CITY OF ARLINGTON, TEXAS

2013 Sidewalk Program
Project No. PWSW13001
Location Overview Map

City of Arlington: Survey List 2

Report No. ECPRW-7209

Front Street
Sidewalks & Ramps

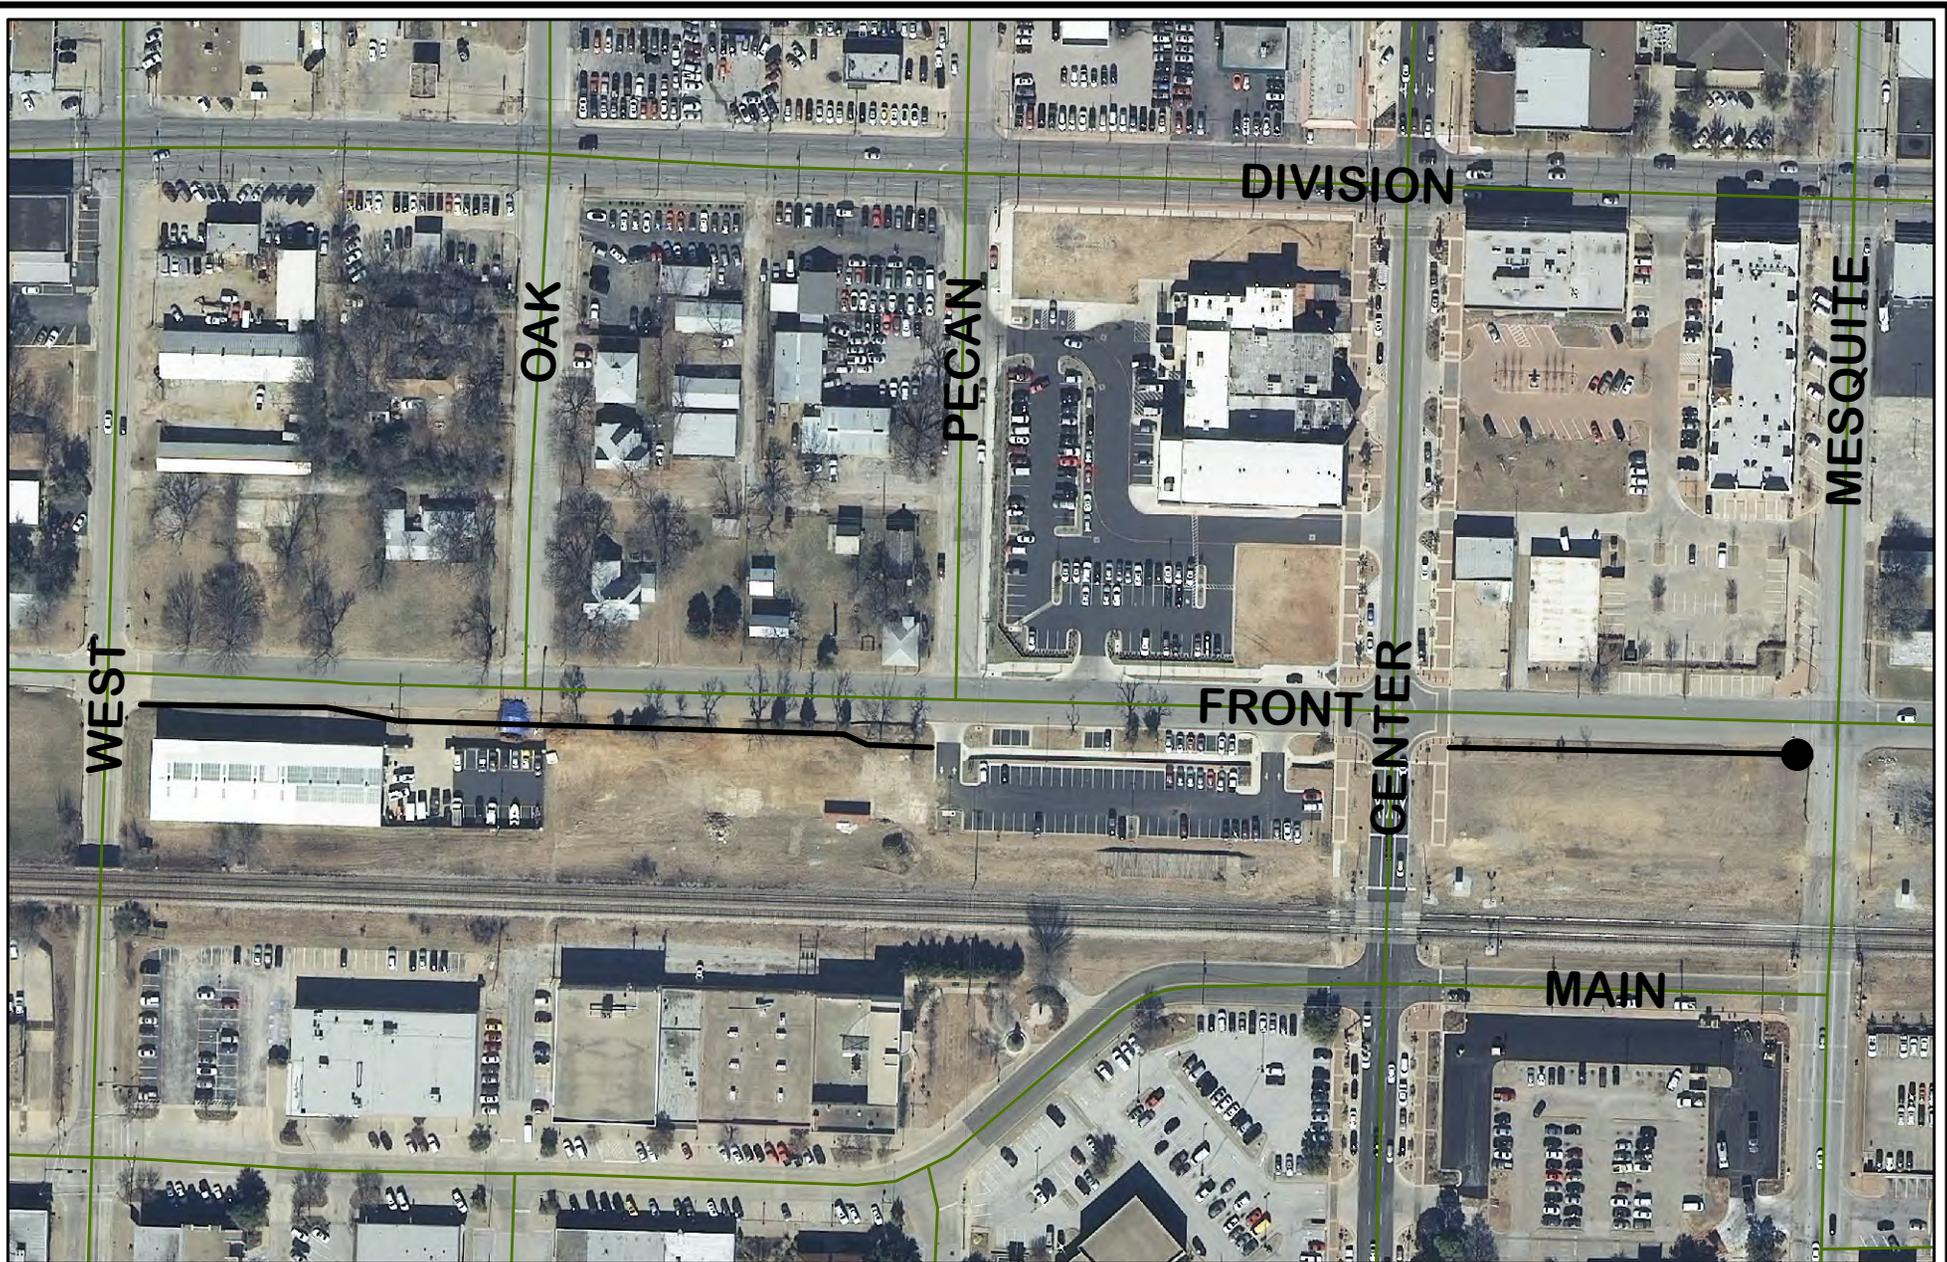
Line	Road System	Segment	From	To	Side	Item No.	Issue	ADA Code	Proposed Correction	P. Level	Photo	City Category	City Notes
		East on Front Street										B	Will add sidewalk to fill in missing gaps on south side of Front between West and Mesquite before and of 2012
		NE corner Border/Elm					no ramp; beyond NE corner, vertical change of 2"					B	Will add ramp and replace section of sidewalk with vertical change before the end of 2012
		Bowen	Sublett	Collard			east side ramps non-compliant slopes					B	Bowen altered in 2001; will add ramps on south side intersection with Bowen and reconstruct ramps at Collard/Bowen within compliance period
		Bowen	Green Oaks	Mandy Way			west side ramps non-compliant slopes, vertical change, missing required handrail, excessive cross slopes					B	Bowen altered in 1996; will address several driveways along this section to eliminate hazards during compliance period

SHEET 5 of 49

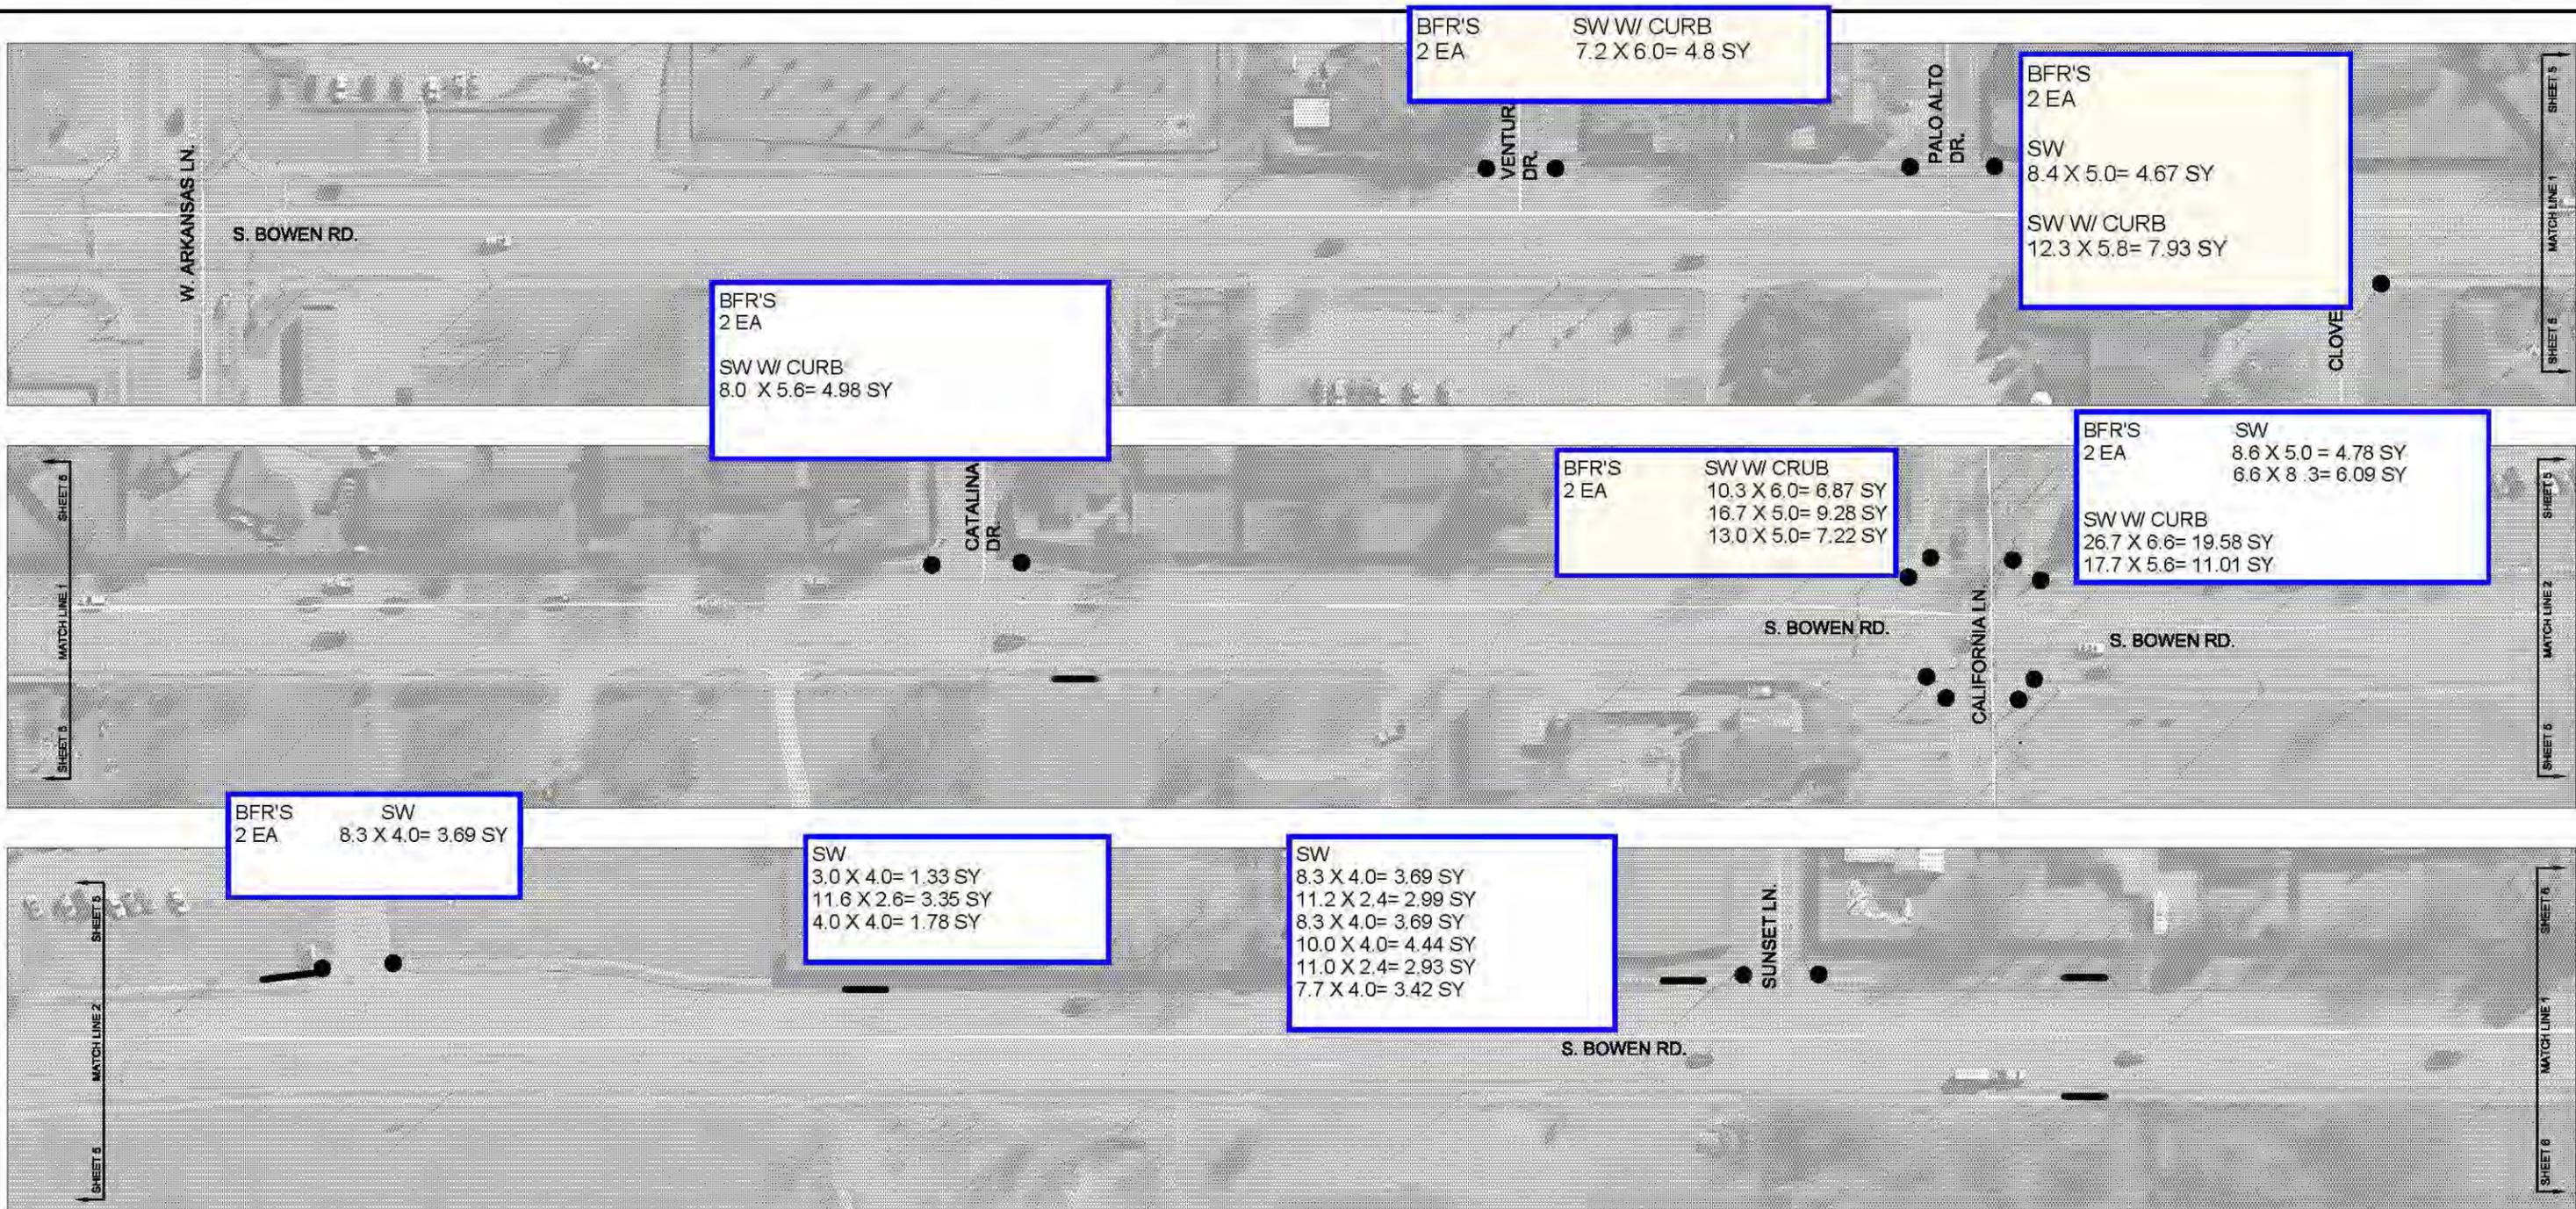
Line	Road System	Segment	From	To	Side	Item No.	Issue	ADA Code	Proposed Correction	P. Level	Photo	City Category	City Notes
		Bowen near Arbrook					east side ramps non-compliant slopes, ped button 46" and no clear space					B	This section of Bowen in City of Dalworthington Gardens but City of Arlington responsible for maintenance through Interlocal Agreement; modified in 1999; will reconstruct several ramps along this section of Bowen within the compliance period
		Bowen near Garden					east side ramp non-compliant slope, ped button 44" and no clear space; sidewalk to Mayfield - vertical change, excessive cross slopes, ramps non-compliant slopes					B	This section of Bowen in City of Dalworthington Gardens but City of Arlington responsible for maintenance through Interlocal Agreement; modified in 1999; will reconstruct several ramps and driveway crossings along this section of Bowen within the compliance period

Bowen	Sunset	California			east side ramp non-compliant slopes, excessive cross slopes					B	This section of Bowen in City of Dalworthington Gardens but City of Arlington responsible for maintenance through Interlocal Agreement; modified in 1999; will reconstruct several ramps and driveway crossings along this section of Bowen within the compliance period

SHEET 7 of 49

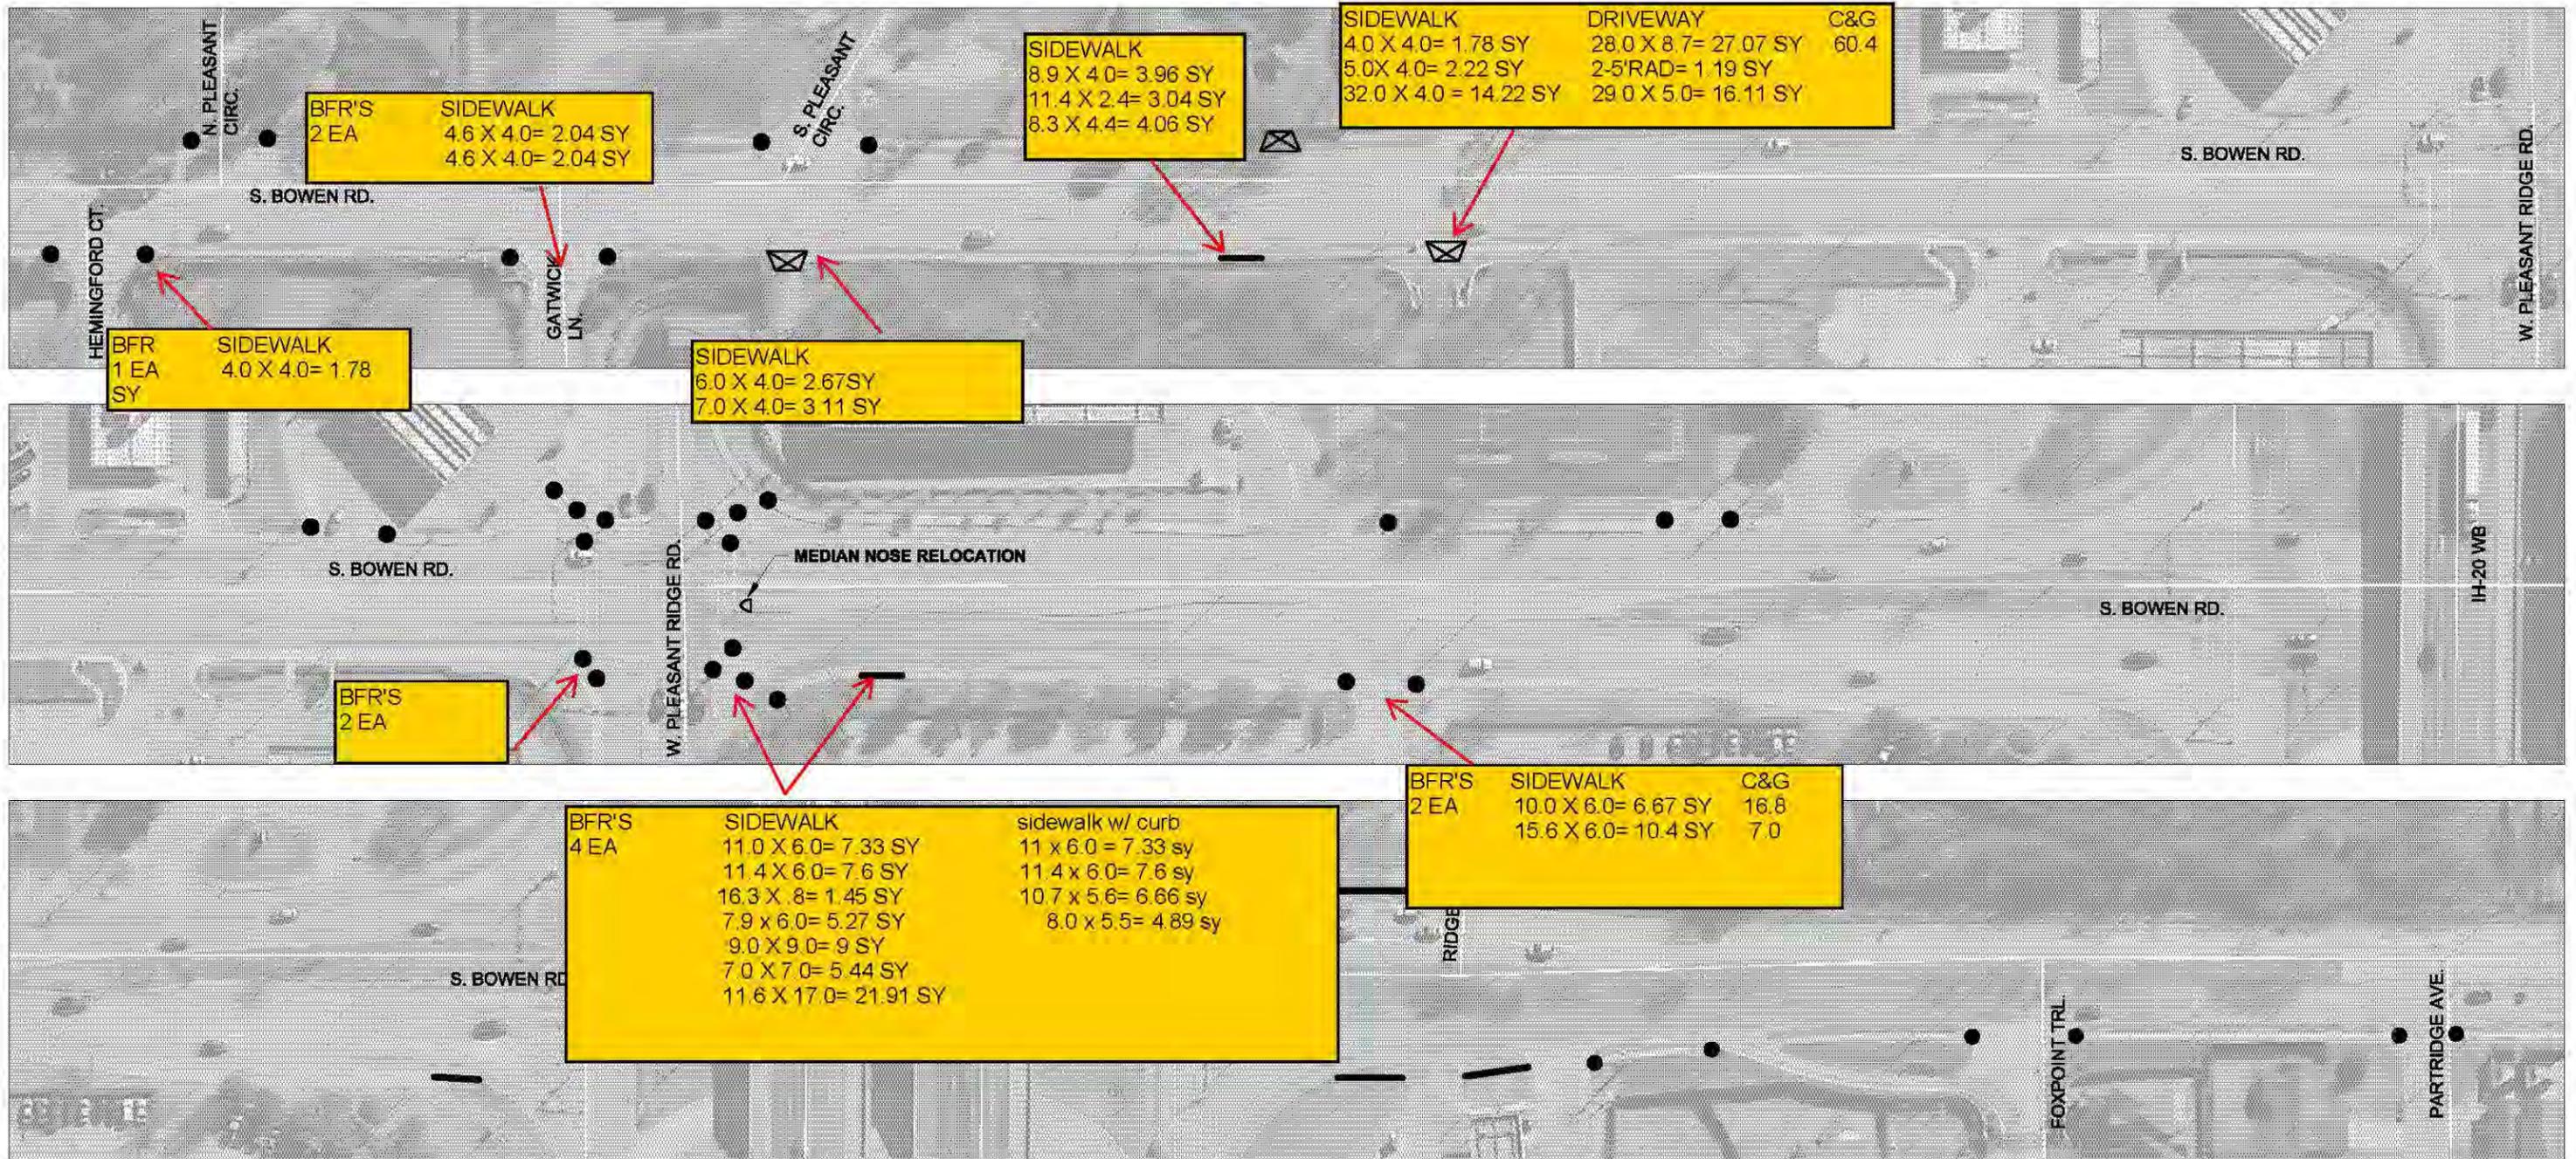
Bowen	IH20	Pleasant Ridge			west side ramps non-compliant slopes					B	Bowen altered in 1995; will reconstruct several areas at driveway crossings on the west side of Bowen along this section within compliance period
		Bowen	IH20	Pleasant Circle S			east side ramps non-compliant slopes, vertical change					B	This section of Bowen in City of Dalworthington Gardens but City of Arlington responsible for maintenance through Interlocal Agreement; modified in 1999; will remove an obstacle in one location along this section of Bowen within compliance period
		Bowen	Pleasant Circle S	Pleasant Circle N			ramps non-compliant slopes					B	This section of Bowen in City of Dalworthington Gardens but City of Arlington responsible for maintenance through Interlocal Agreement; modified in 1999; will address obstacle at one driveway location within compliance period
